**Response to Request for Additional Information – ANP-10273P
“AV42 Priority Actuation and Control Module Topical Report” (TAC No. MD3867)**

Figure 04-1

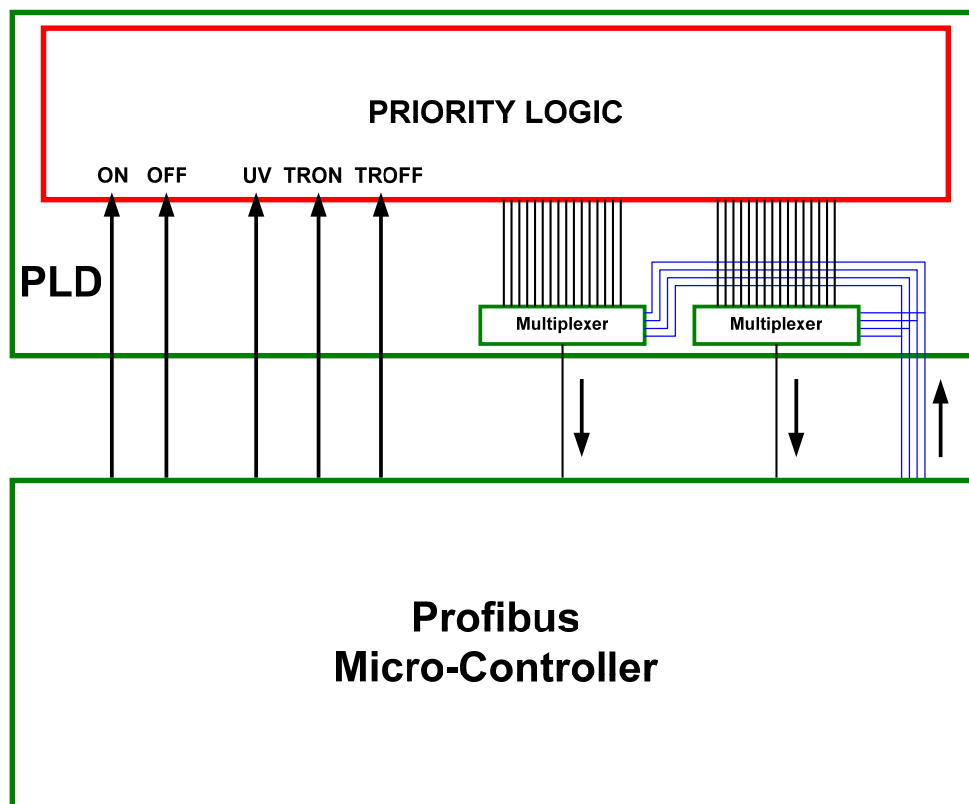
RAI 04: Figure 4-1, “AV42 Interfaces and Communications Links” shows communication from non-safety to safety and from safety to non-safety, as black arrows. **For non-Safety to Safety communication**, Section 4.8 contains a conceptual description of the control scheme. The AV42 TR does not contain a description of the number of inputs and outputs for performing this function, nor the functional meaning of each. Please provide sufficient details to allow the NRC staff to understand the function and arrive at an independent conclusion that the regulations and guidance for non-safety to safety communications are met. This needs to include, but is not limited to the logic design, what information is communicated, and how the safety function is protected.

The Non-safety to Safety communication is performed through five (5) hardwired signal traces on the printed circuit board (PCB) of the AV42. These non-Safety to Safety signals originate from the Profibus Micro-controller and are sent to the PLD. The five signals are described below. Please refer to Figure 04-1 for a functional representation of the signals passed between the PLD and the Profibus Micro-controller. Also, please refer to RAI-03 for a description of each hardwired input and output pin as referenced in the text following Figure 04-1.

The safety function is protected by the priority logic of the PLD. Under no circumstances, can an operational command override a safety command. Safety commands always have priority over operational commands. The AV42 is 100% testable to ensure this feature. There is no parameter / setting that the user / installer could change that would result in an operational command overriding a safety command.

The logic configuration on the PLD is unaffected by communications commands. Commands from Profibus are forwarded to the PLD; the priority logic within the PLD will determine what command is sent to the actuator. If a safety command is issued, Profibus commands are blocked and the safety command is then sent to the actuator. The Profibus communications cannot alter the PLD logic, nor can it override a hardwired safety command.

Figure 07-1
Front Panel of AV42.

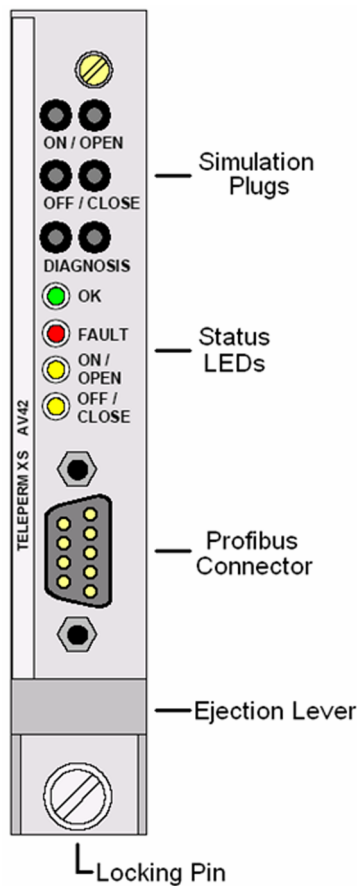
RAI 07: Please provide details on the use of any simulation and testing features.

Input simulations can be performed on the AV42 during maintenance and/or commissioning of the plant. There are three (3) simulation plugs located on the front of the AV42. A simulation plug is a two pin, female, shrouded connector. To issue a simulation command, a jumper wire will be inserted into the simulation plug to short the two pins together. The simulation commands are Open, Close, and Diagnosis. Shorting the Open or Close simulation plugs will cause the AV42 to issue an open or close command, respectively. Shorting the Diagnosis simulation plug will prevent any I&C system from exercising the actuator. The Diagnosis simulation plug is a lockout feature.

The simulation plugs are located on the front of the AV42. Simulation plugs are only used during maintenance and/or commissioning of the plant (not during normal operation of the plant). Administrative controls must be implemented in order to prevent simulations from being performed during normal operation of the plant.

Please refer to Figure 07-1 for a diagram of the AV42 front panel layout.

Figure 24-1
Representation of a general Profibus segment with AV42s.

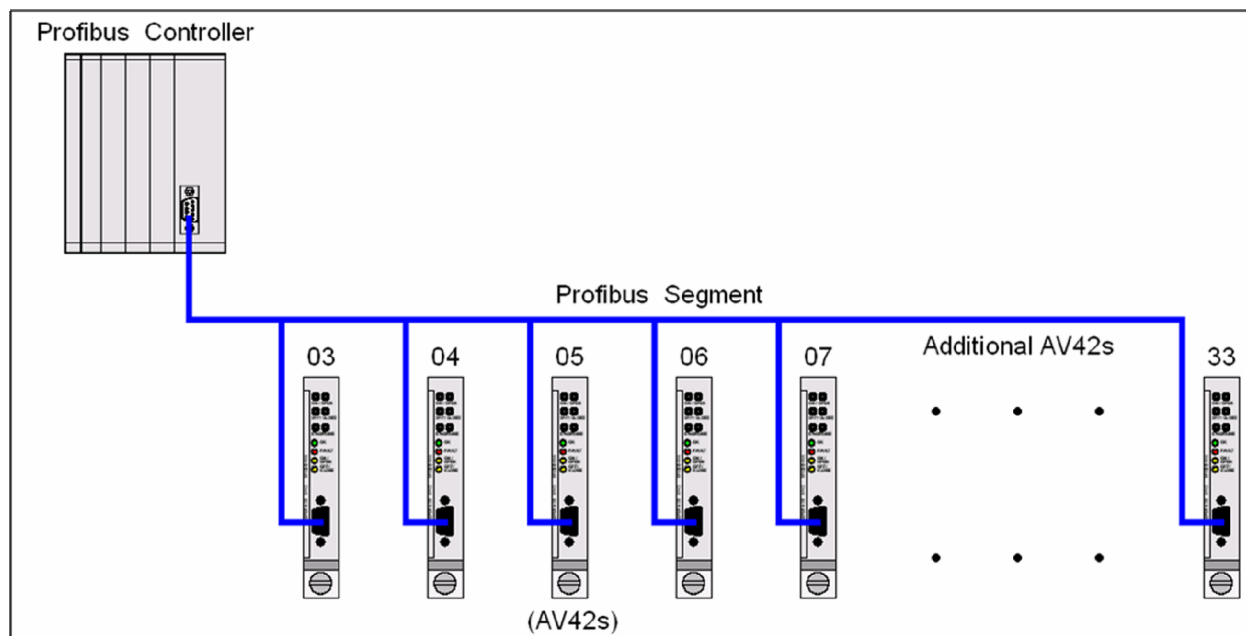
RAI-24: *The AV42 has the capability to be connected to a non-safety network. It is not clear from the description if: 1) each AV42 is connected to a single node (e.g. a point to point network), 2) all AV42s in one safety division are connected to the same non-safety network, or 3) there is only one non-safety network that all AV42s are connected to. Please clarify the intended configuration. If multiple AV42s are connected to one non-safety network, then please provide any design criteria governing a set of allowable connected components.*

Multiple AV42s can be attached to a single non-safety network, but there are limits to how many can be attached to a network.

The AV42 Profibus address is set by wiring the 6 address pins to high or low. The address pins are pin B18 through B28 []. A 6-bit binary number has 64 possible combinations (0 through 63). Of these 64 possible combinations, only 30 are valid for use with the AV42. Therefore, up to 30 AV42s can be attached to a single Profibus segment. A Profibus segment is defined as a “data network” that creates a physical connection between a Profibus controller (could have redundant controllers) and slave modules (in this case the slave modules are the AV42s).

For the U.S. EPR design: All AV42s, on a single Profibus segment, will be physically located and will control actuators within the same division as the respective Profibus controller. No Profibus segments for the AV42s will cross divisions. Also, a dedicated Profibus segment will be used for AV42s. If a Profibus segment is designated to interface AV42s, no other data acquisition or control modules (other than the AV42s and the Profibus controller) will be attached to the segment.

Figure 30-1
U. S. EPR functional representation of Manual System and Component level actuation.

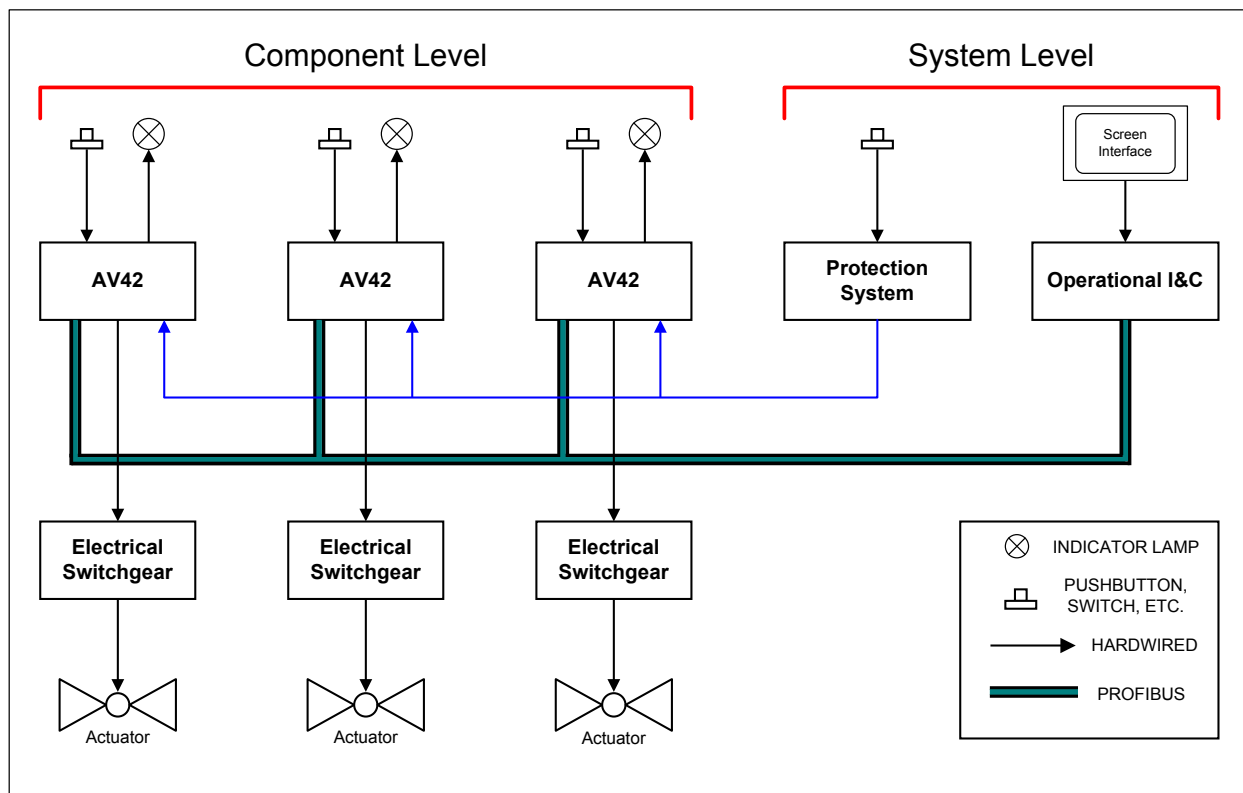
RAI 30: Section 4.6 says, “Manual controls enable the operator to initiate protective actions at the system level as well as the individual level”. Please describe these design details and provide examples.

As indicated in the response to RAI 14, the AV42 supports manual initiation of protective actions at the system level in two ways. Manual system level and individual level control configurations are part of the overall I&C architecture for a given plant and are therefore outside the scope of this Topical Report; however, design details and examples on manual system level actuation are given in the response to RAI 18 of the U. S. EPR Protection System Topical Report RAI responses in ANP-10281P. A functional representation of typical system and component level actuation using the AV42 is presented in Figure 30-1 below. (“Component” being synonymous with “individual” as stated above and in section 4.6 of the topical report.)
